# Summary of Pre-App Discussions

## Current Proposal in Response to August 2018 DRP Feedback

### Design Review Panel Comments (August 2018)

## DRP Proposal and Response (Iteration 04)

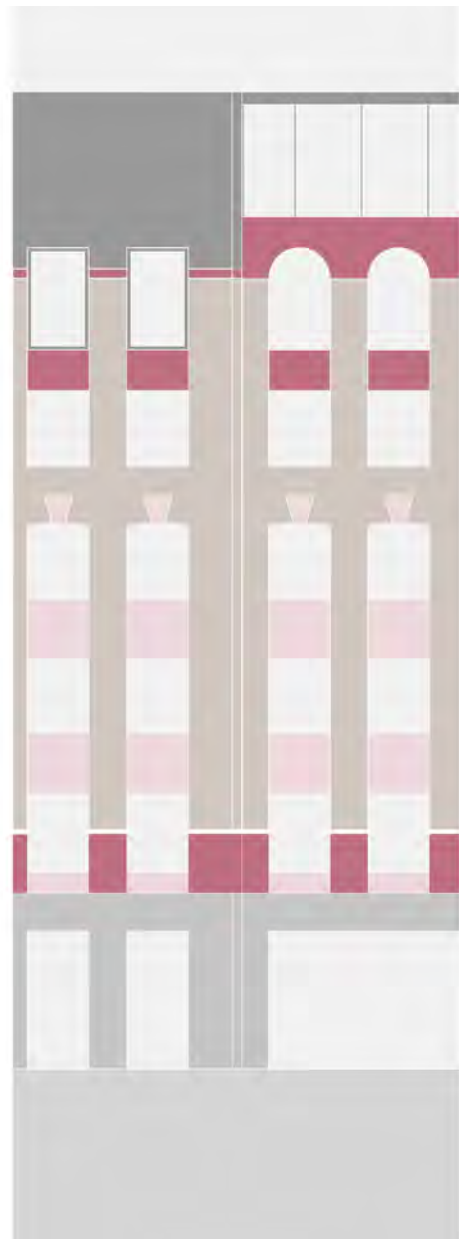
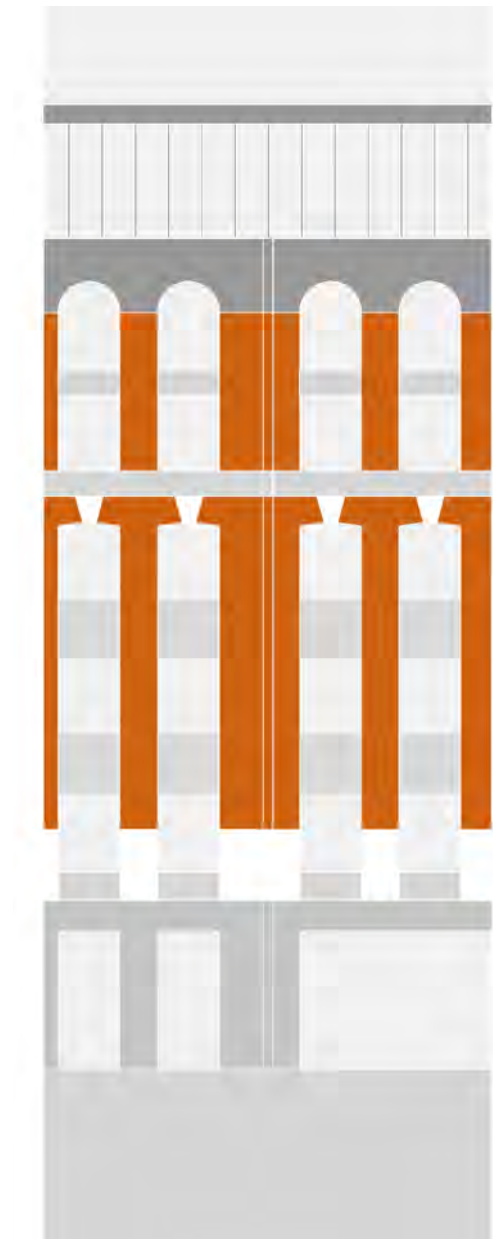
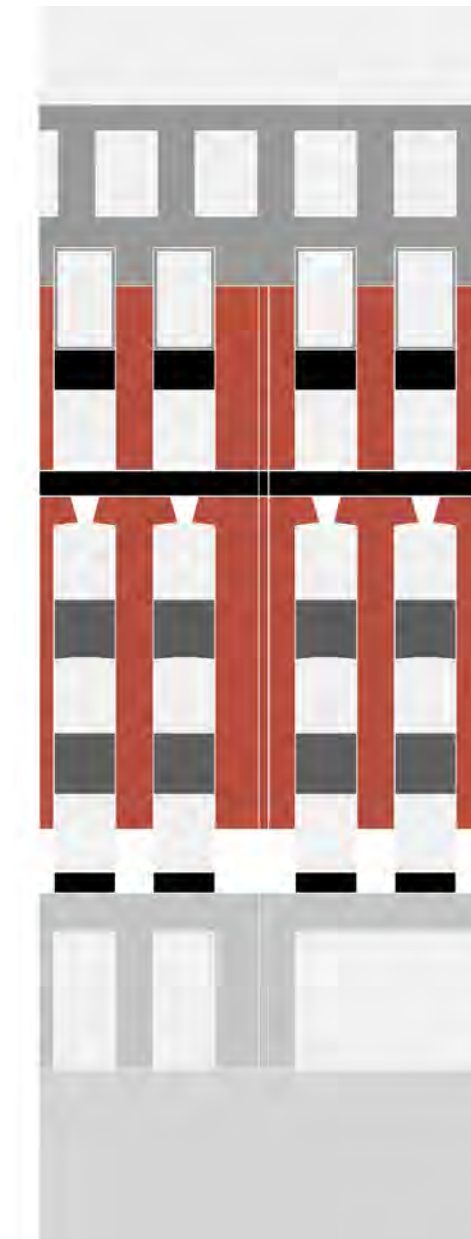
**Pre Application Meeting Comments  
(March 2018)**

The height of the two storey extension was acceptable in principle.

Agreed that the proposed design must remain subordinate to the corner building

LBC stated that their main concern regarding the scheme was the parapet line

Current proposal to push out the building line at the ground floor and the removal of the columns would be acceptable in principle

Arched window heads and raised parapet detail with mansard sprung from it

Lowered shoulder height with dormers breaking the line on one side and an arched window head detail on the other

Shoulder height dropped further and dormer detail extended across each facade

Window, shoulder and parapet heights reduced further. Arches above set back from the facade and finished to read with the roof, or a set-back brickwork detail

- Adjusted the parapet weight
- Set-back the top floor
- Uses the existing structural line to deliver more character and visual richness to the Parker Street roofline whilst allowing the building to be read compositionally as one building

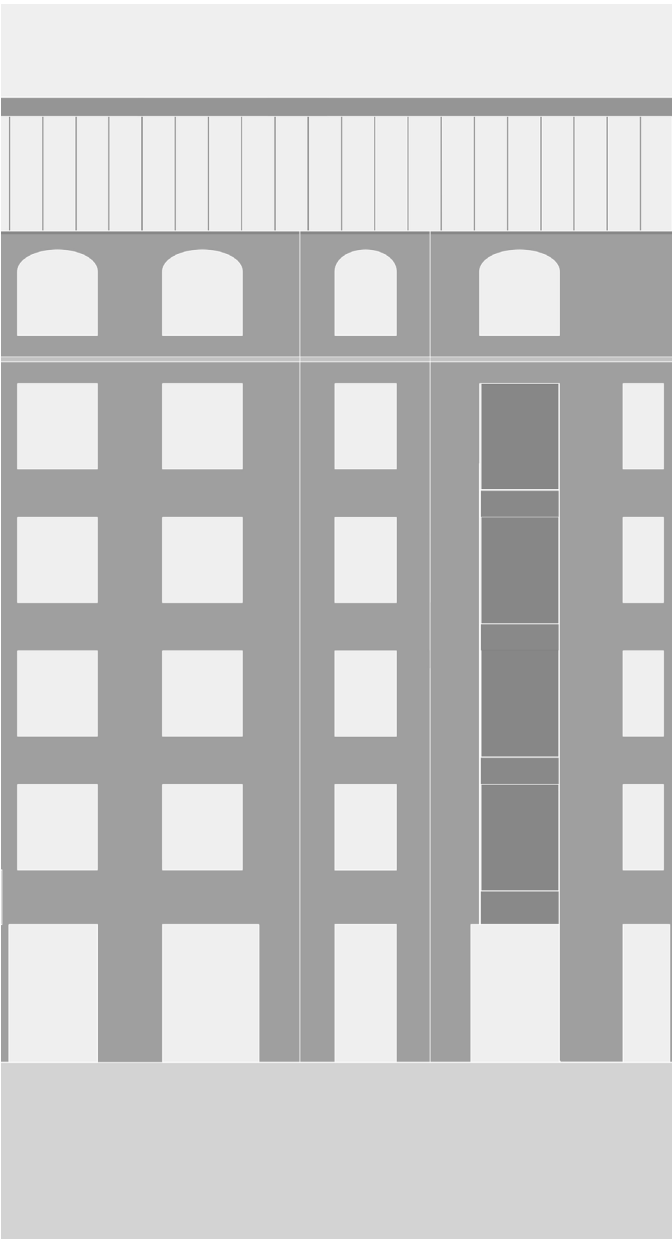
"Opportunities to set the roof back and extend the roof terrace could also be explored, with reference to the neighbouring roof gardens on Parker Street"  
*The warehouse roof sits back from the parapet line, and terraces feature at either end of the scheme.*

"The characteristics of depth and detail [at the] ground floor should be retained"  
*More piers sit at ground level, and the depth and detail of the reveals has increased.*

"The panel also thinks that the proportions of the elevation could be refined to simplify and clarify the design"  
*Using the historic structural grid has calmed the elevation through creating a smaller number of larger bays. Simpler openings and fewer elements add greater simplicity and clarity.*

"There is a case for a more muted approach to the tone of materials, in greater sympathy to surrounding facades"  
*The facade uses fewer materials and the ones that feature are more muted, referencing the many warehouses of the Seven Dials conservation area.*

"The panel endorses the decision to design a single building rather than breaking the site into two along the existing structural line"  
*The new proposal reinforces the idea of appearing as a single building, the structural line creates relief in the facade but everything reads as a whole*

"Current elevations are too over complicated and include too many different elements"  
*A full reclad of the existing structure removed the need to retain any of the existing details. Now, the facade is made of a uniform brick surface, with the metal of the window frames and balustrades being a consistent, quieter colour*

"The initial design approach took a simpler approach, which the panel considers could be revisited"  
*Like 'Iteration 1', the proposal references its warehouse context materially and formally. The simplified design sits more comfortably within its Seven Dials context*

"The panel feels the retention of the concrete frame is the right approach"  
*The frame is still retained, but the cavity wall is removed in its entirety*

"Brightly coloured glazed brick will stand out in relation to the surrounding area, regardless of the colour chosen. This approach should be carefully considered, as a more muted palette may be better suited to the conservation area and to the materials used in neighbouring buildings"  
*A more muted bespoke brick will be used throughout*

"If glazed brick is used, it should be of a very high quality to ensure a textured non reflective surface suited to use on an entire facade"

"The proposed metal band capping the sixth floor adds complication to the elevation, and to the materiality of the building as a whole. Consideration could be given to removing this and simplify the range of materials"  
*The metal capping is on of many details removed from the proposal. Now the interest is achieved now through large palette of materials, but subtle details within the uniform brick facade*

*Using a bespoke brick will allow us to specify the level of reflection and ensure a high quality finish*
